**Amendment to the Drawings:**

**REMARKS/ARGUMENTS**

FIG. 4

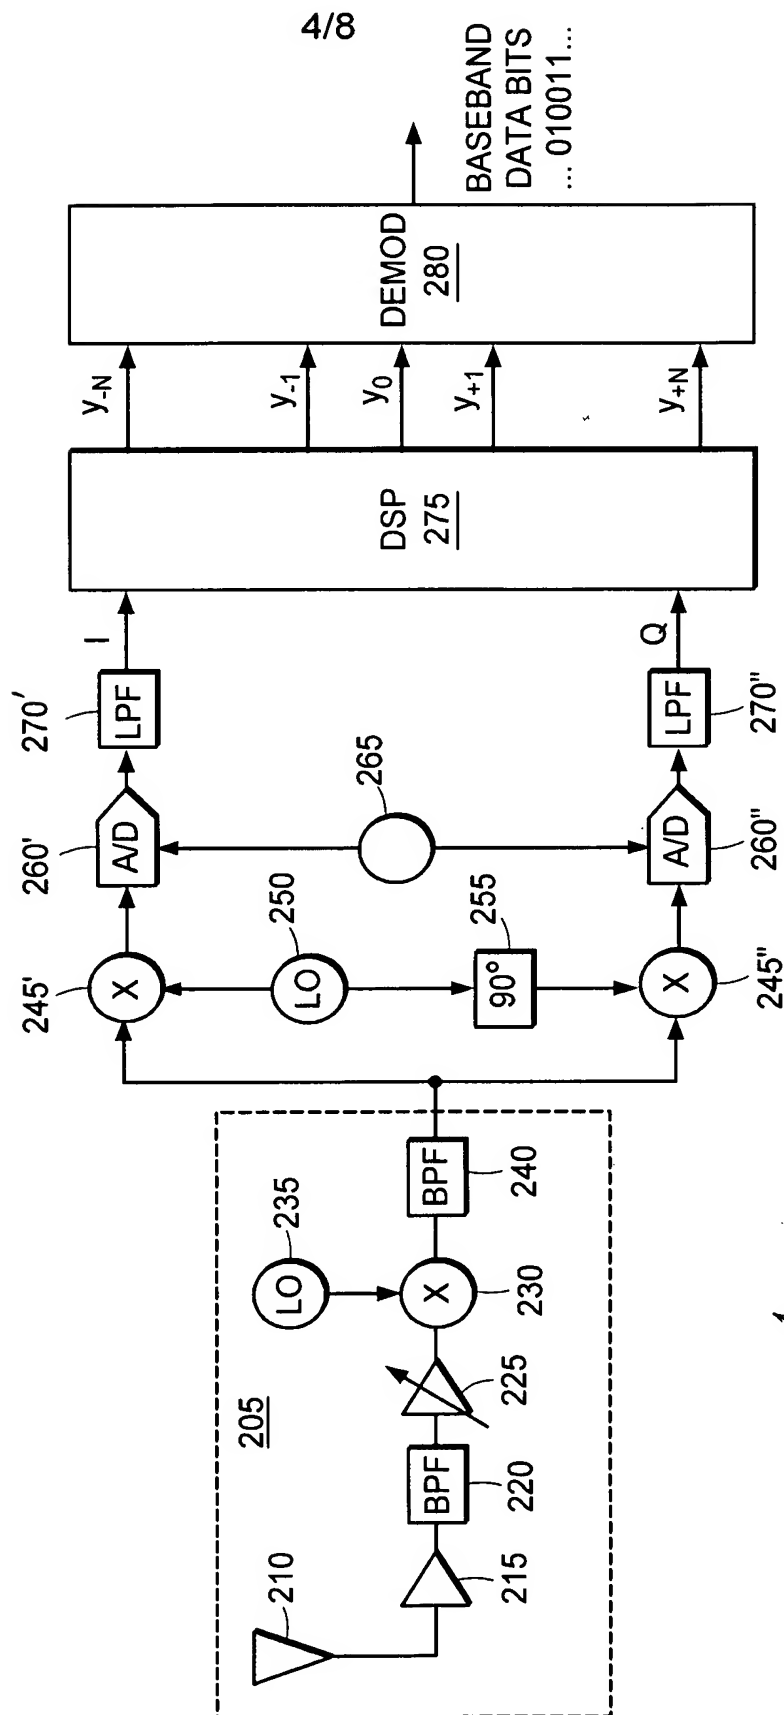
Please replace drawing sheet with Figure 4 with amended drawing sheet with Figure 4 attached herewith. Reference numeral 270 is changed to 270'.

The drawings have been objected as failing to comply with 37 CFR 1.84 (p)(5). The specification pages 9-11 and the drawing sheet with Figure 4 have been amended in view of the Examiner's objection. In addition, page 16 of the specification has also been amended to correct an inadvertent typographical error.
